METROPOLITAN GOVERNMENT OF NASHVILLE AND DAVIDSON COUNTY

STAFF RECOMMENDATION 110 Second Avenue North September 16, 2015

Application: New construction-rooftop addition, Signage, Alteration-window replacement

District: Second Avenue Historic Preservation District

1 ROOF PLAN - MHZC
1/16" = 1'-0"

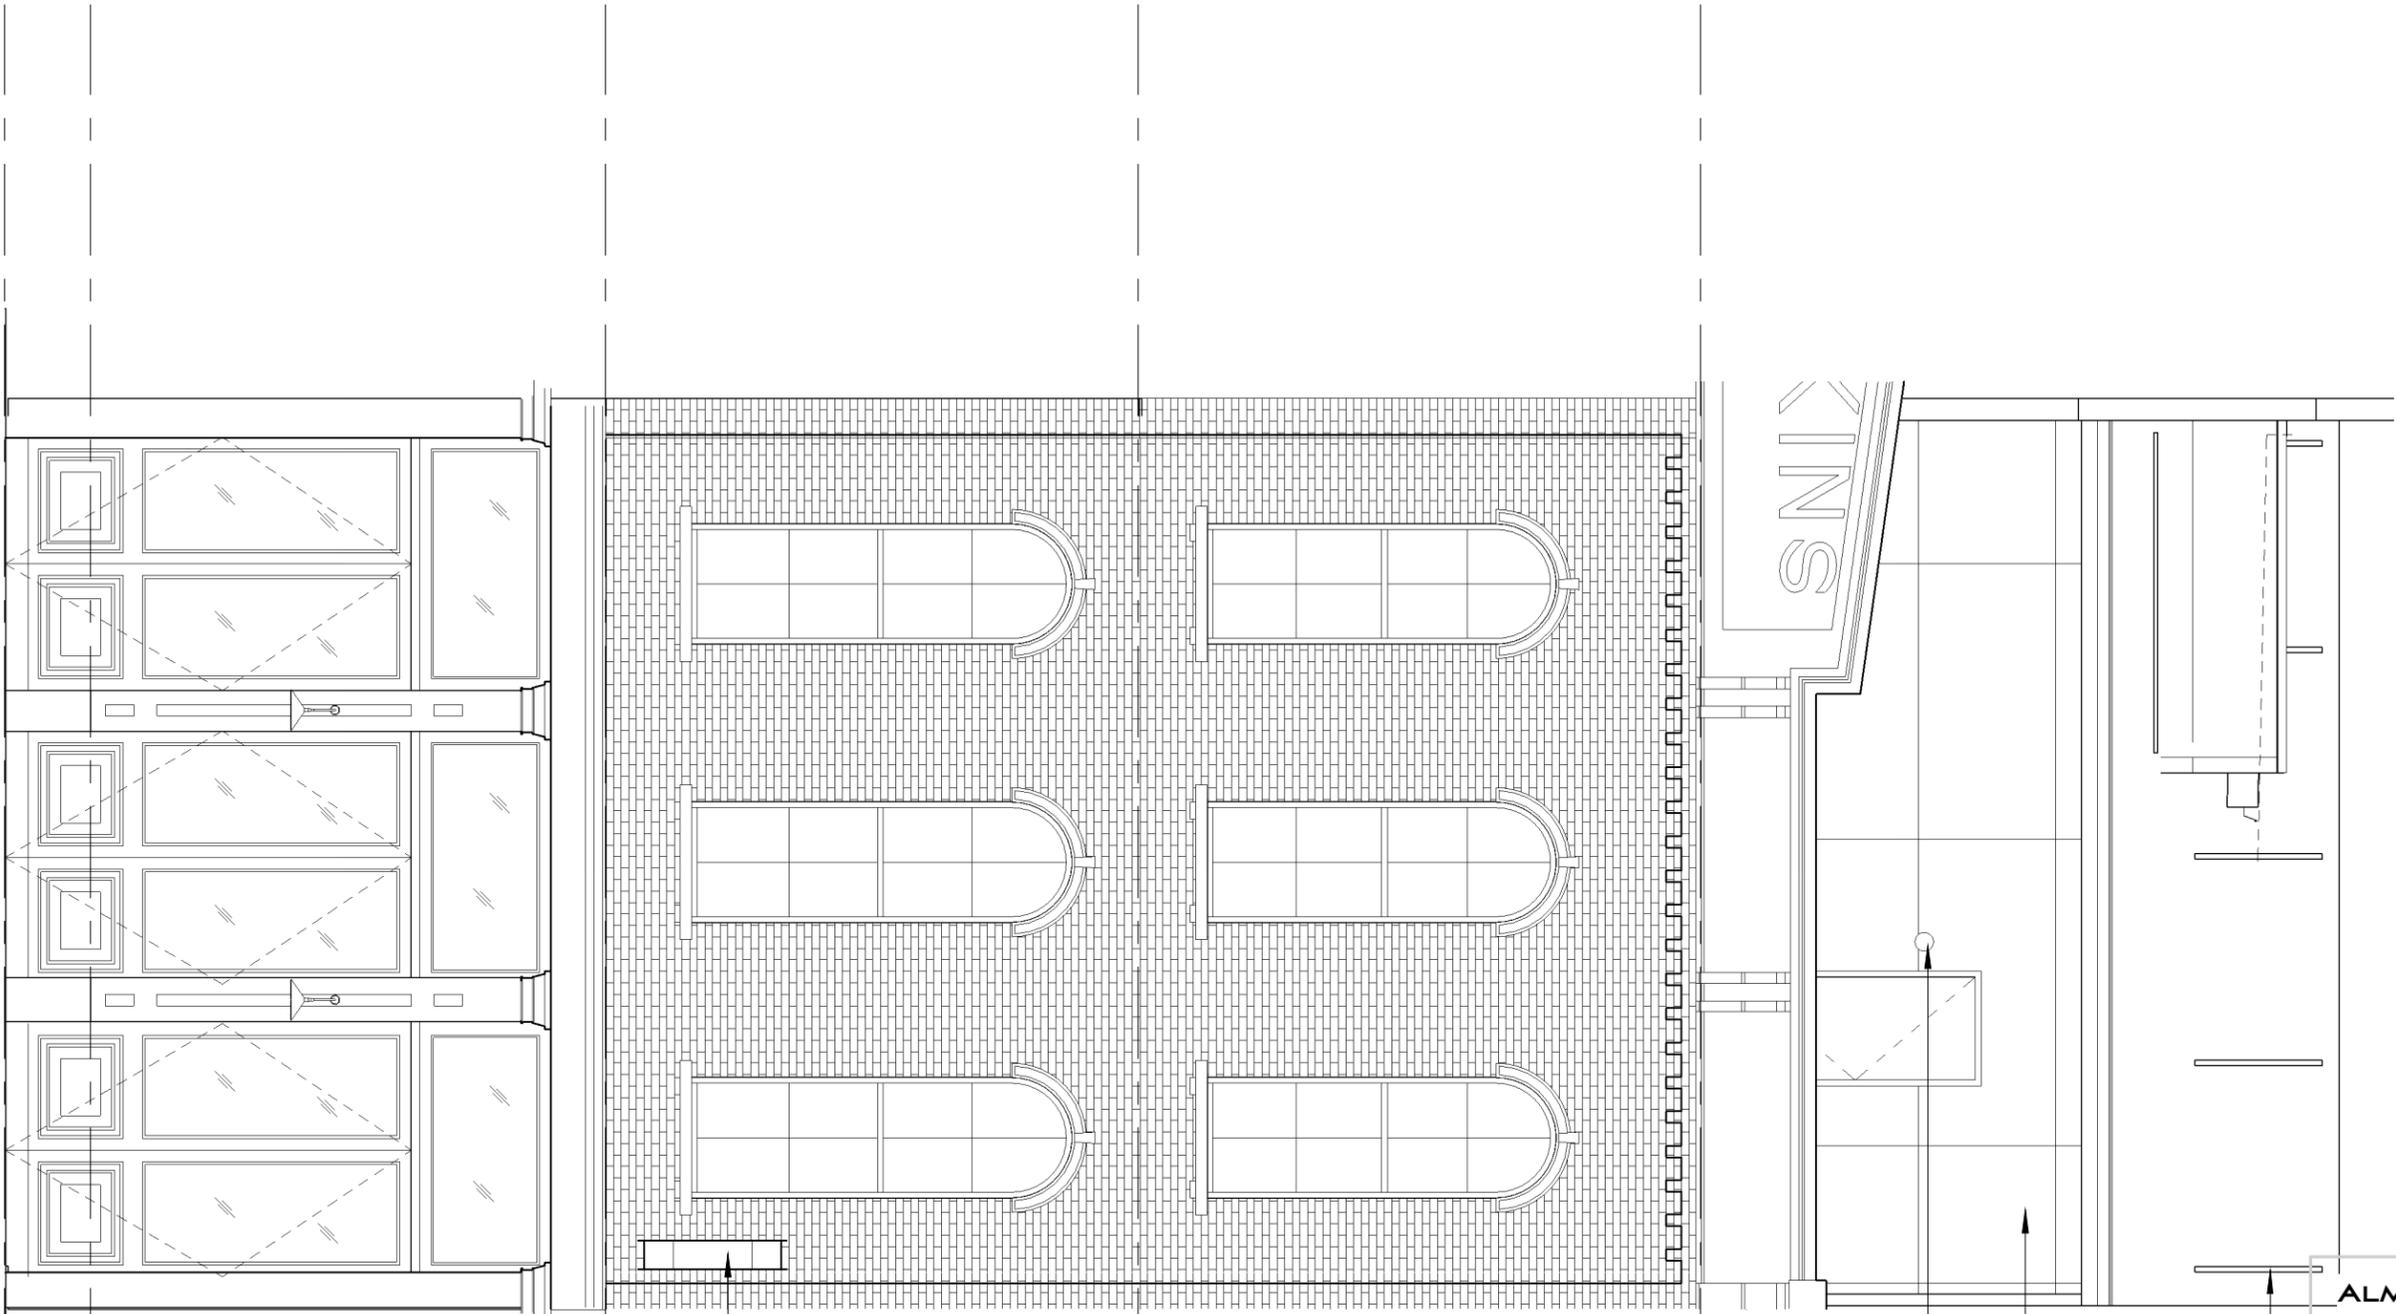
Height and Scale: The project includes a rooftop addition that more than meets the requirement of a minimal thirty foot (30’) setback from the Second Avenue wall with a setback of more than sixty-one feet (61’ 6 ¾”). The First Avenue wall meets the minimal ten foot (10’) setback. The railing on the First Avenue side only sits back eight feet (8) which the Commission has allowed in the past for railings.

Rooftop additions should be no more than one-story and approximately fifteen feet (15’). On the Second Avenue side, the rooftop addition does not exceed fifteen feet (15’) from the lowest portion of the parapet wall. It does exceed fifteen feet (15’) in two places, for the CMU elevator shaft and the First Avenue side of the addition which includes a sign above the roofline. The elevator shaft is less than one foot (1’) taller than the maximum and located towards the center of the roof. Because of the minimal additional height, the minimal portion of the addition that exceeds the maximum and the location, staff finds the additional height of the elevator shaft to be appropriate. The signage above the First Avenue wall of the addition already does not meet the design guidelines for signage but also causes the addition to exceed the height maximum. With its removal, the addition will otherwise meet the maximum height requirement. Staff recommends removal of the signage above the addition to meet the minimal height requirements and the signage location requirements.

Applicant plans to add speakers to the rooftop and the rooftop addition but the locations were not indicated. Staff recommends final review of dimensions and locations.

- The top proposed sign of the First Avenue side be removed because it exceeds the allotment for signage, is located in an inappropriate location, and causes the addition to exceed the height maximum;
- Signage not include bare bulbs;
- The railing on the First Avenue side not be used to support additional elements such as speakers, lighting, plants or signage;
- Staff approved dimensions and locations of speakers; and,
- Staff review final masonry prior to purchase and installation.

1 2ND AVE FACADE
3/16" = 1'-0"

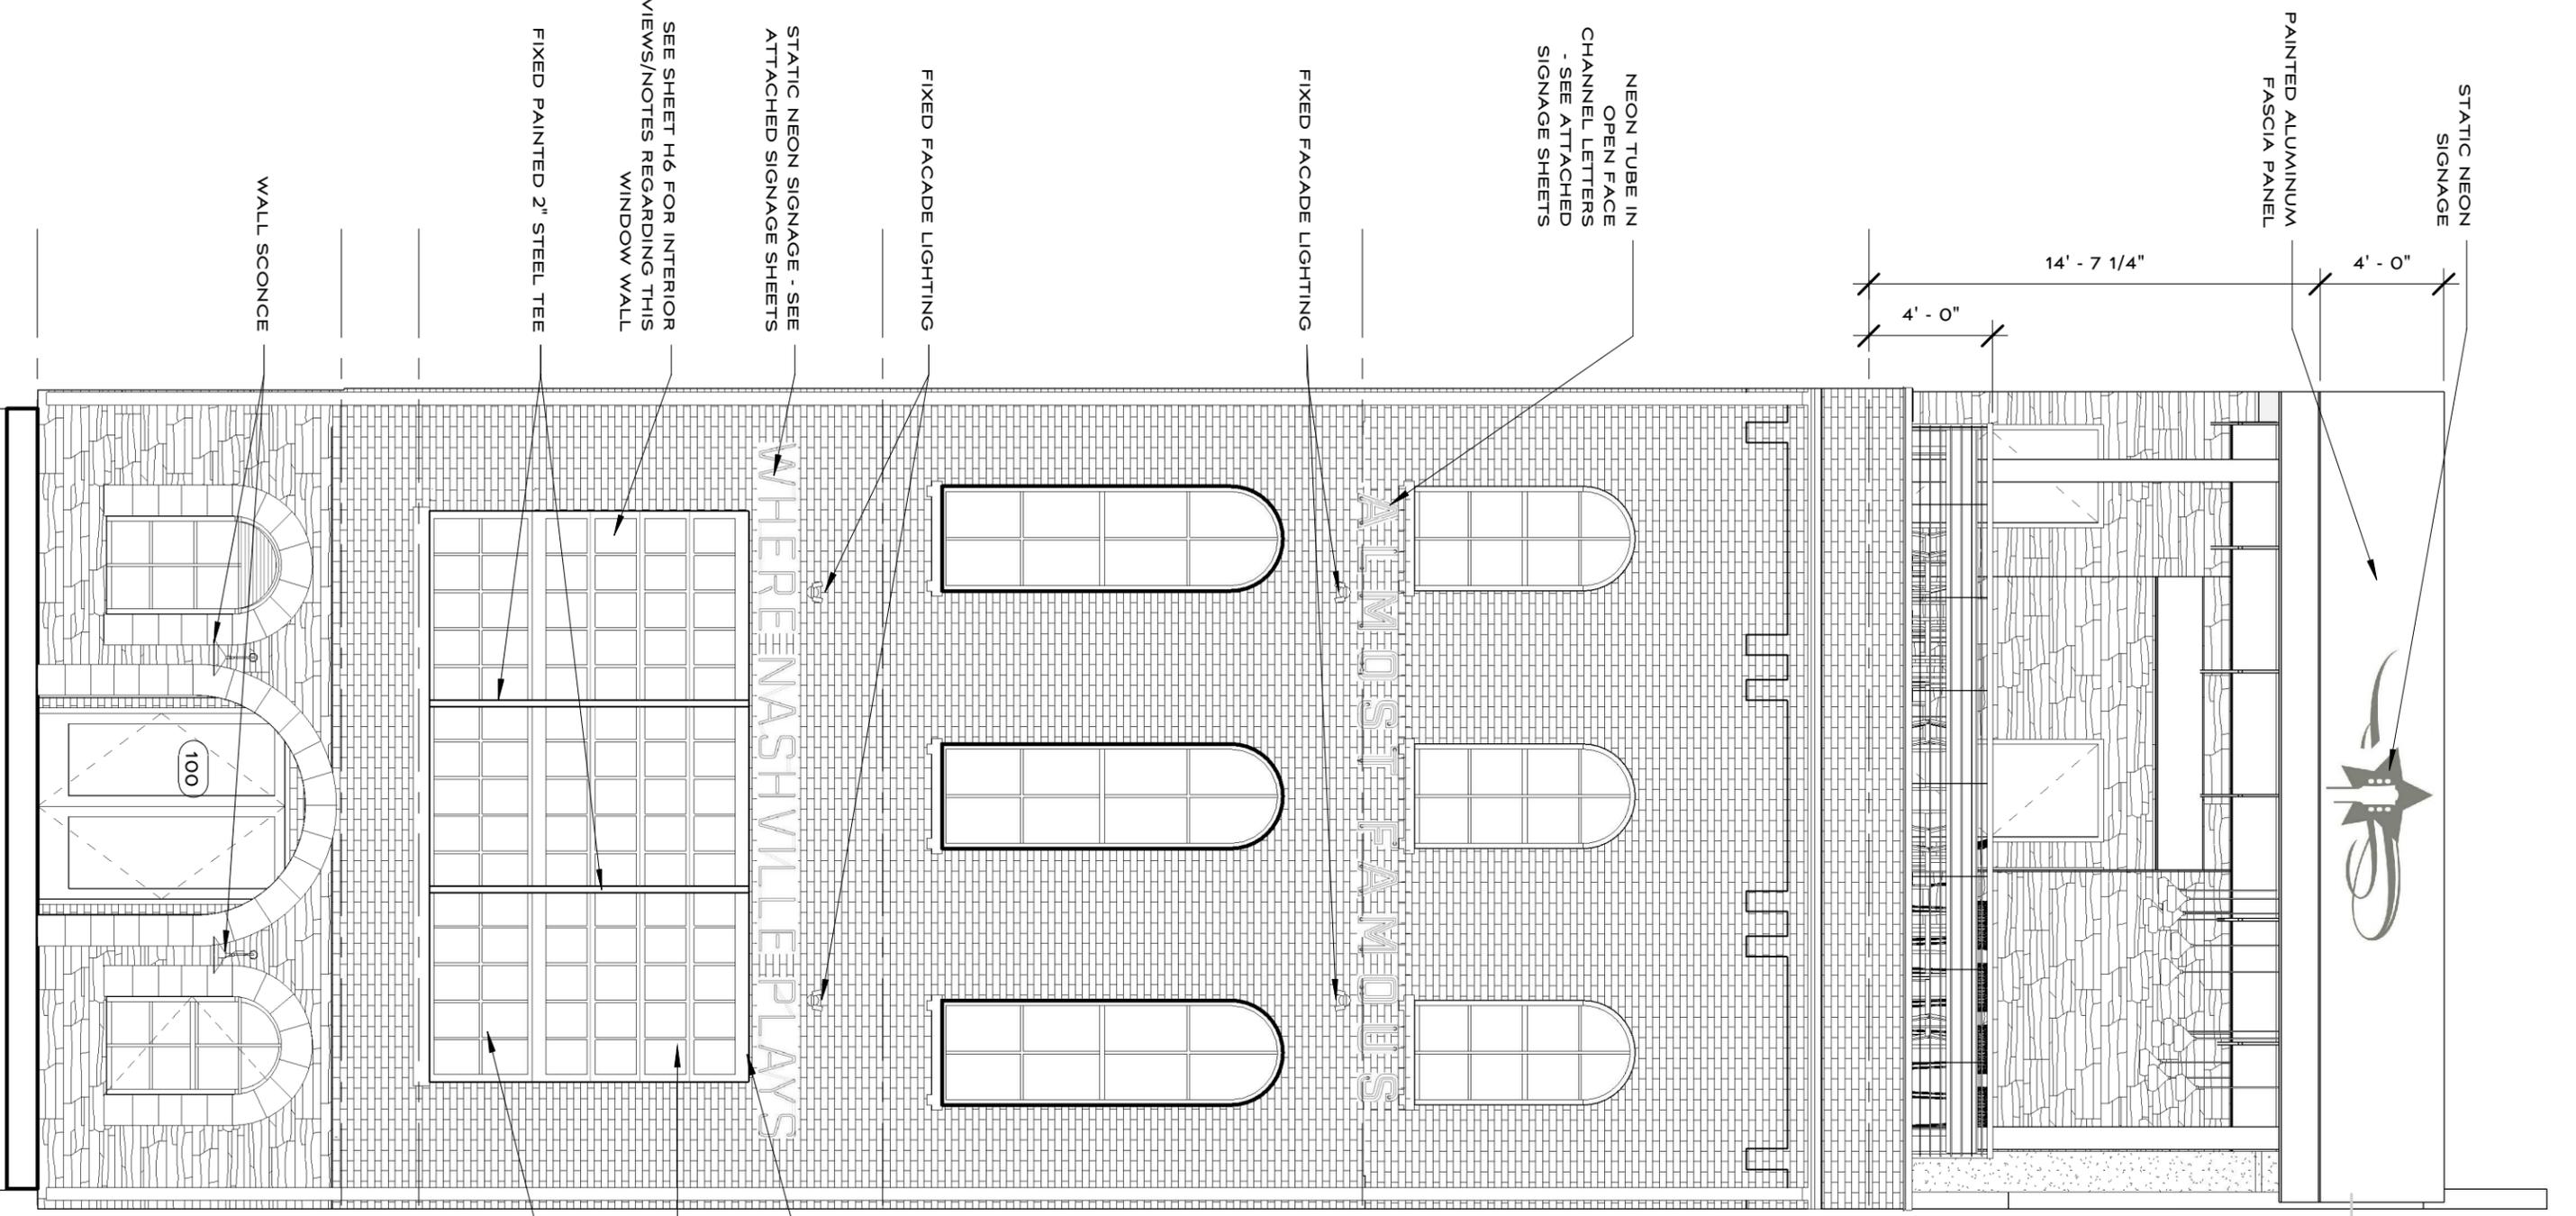
There is one projecting sign proposed for the Second Avenue side where the allotment is fifty-three square feet (53 sq ft). The proposal is for a twenty square foot (20 sq. ft) neon sign. The applicant claims that the proposal meets the requirement that it be at least twenty-five feet (25’) from any other projecting signs. The sign does not obscure architectural details and is located in an appropriate location. The design guidelines require that the sign have a minimal of spacing from the building of twelve inches (12”) and not project more than a total of six feet (6’). The proposal meets those specifications. The depth of the cabinet meets the maximum of eighteen inches (18”) and the height of the sign does not exceed the maximum.

The project includes bare bulbs along two sides of the sign; however, this is a “prohibited” light source according to the design guidelines. Staff recommends that the bare bulbs be removed from the design.

1 1ST AVE FACADE - MZHC
3/16" = 1'-0"

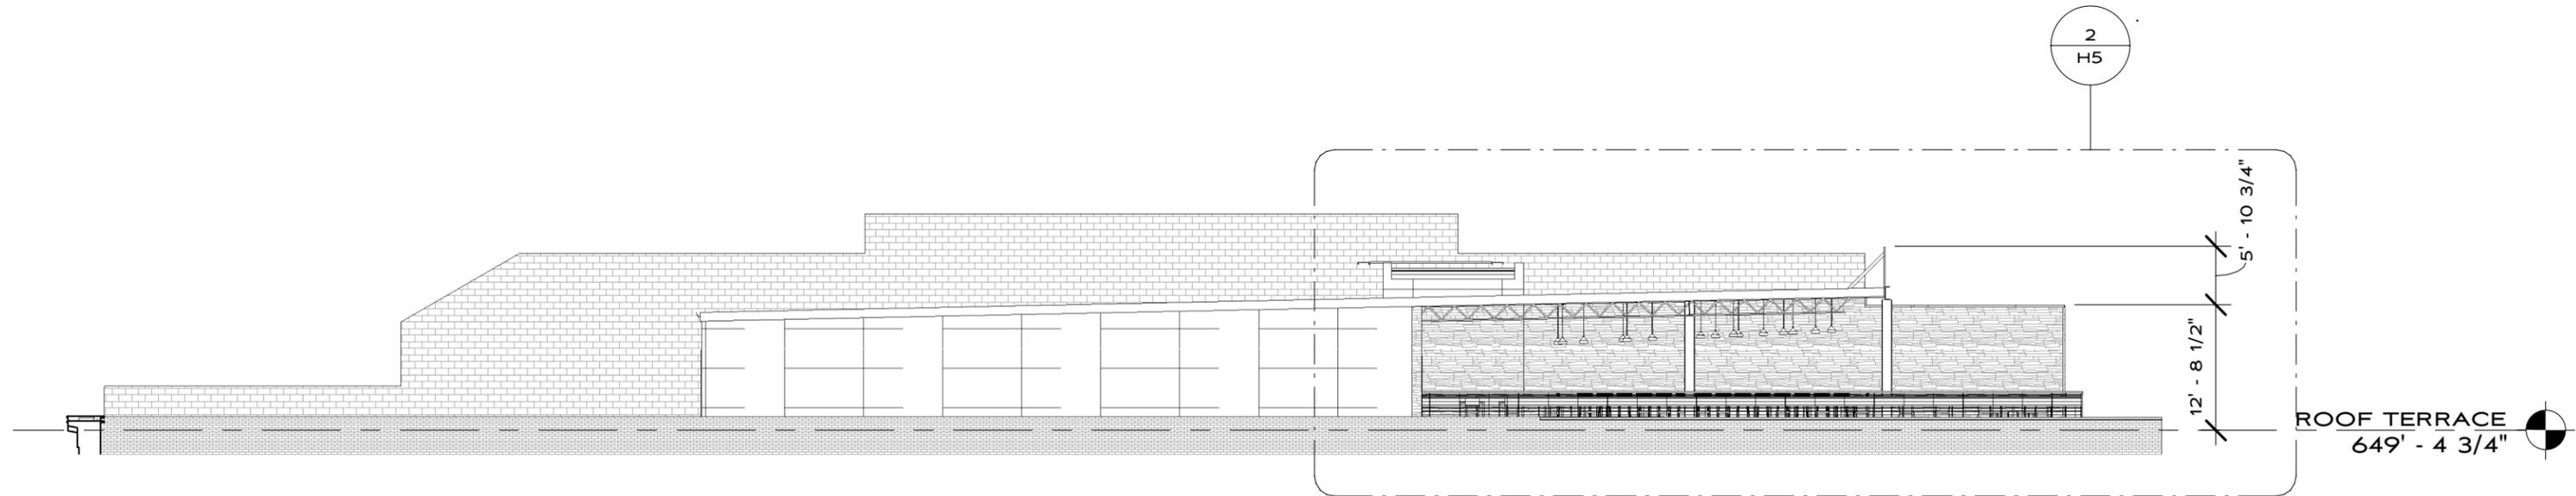
Staff has analyzed the existing window and finds that although it could be repaired, replacement is also a reasonable treatment option, due to its poor condition. The applicant proposes a fixed window along the bottom with $\frac{3}{4}$ of the upper portion of the opening being a rollup door. Because the floor will be raised on the interior, the bottom $\frac{1}{4}$ of the opening will be obscured glass. The applicant did not specify how that will be accomplished.

The raising of the floor level does not meet the design guidelines for “upper facades: general principles” which states that “interior changes that affect the exterior appearance of upper facades including lowering ceiling heights or raising floor levels should be avoided.” The raising of the floor level requires the reconfiguration of the window and the need for obscured glass.

The Commission has not approved rollup doors on upper facades or primary facades in the past, finding that they do not meet the design guidelines that require that replacement windows “should replicate originals” and that “steel windows should be replaced with steel or aluminum designs that replicate the appearance of the original window” and because rollup doors are not found on upper levels or primary facades historically.

The industrial steel windows were a common alteration of the First Avenue side of this block and have become historic in their own right. A window with a fixed window in a portion of the opening with obscured glass and a roll up door is not a design that replicates the original. The Staff recommends disapproval since the proposed window does not match the historic windows and therefore does not meet section II.H.3 for window replacement or section II for rehabilitation: upper facades, general principles.

There are three neon wall signs proposed on the First Avenue side of the building. The allotment on this side of the building, for wall signs, is approximately forty square feet (40 sq. ft.) All three signs together total fifty-nine square feet, greater than the allowed allotment. The top sign does not meet the design guideline that states that “no portion of a wall sign may extend above the roof line or above a parapet wall.” This sign extends above the roof of the addition and above the parapet wall of the existing building. Staff recommends removal of the top proposed sign, because it exceeds the allotment and is located in an inappropriate location and to lower the total square footage of the remaining two signs to meet the forty square foot (40 sq. ft.) allotment. Since the creation of the current signage guidelines which match the overall DTC requirements, the Commission has not approved any signs to exceed the allotment or to be located in inappropriate locations.

Staff recommends disapproval of the replacement of the historic industrial window with a roll-up door finding the project does not meet section II.H.3 for window replacement nor section II for rehabilitation: upper facades, general principles.
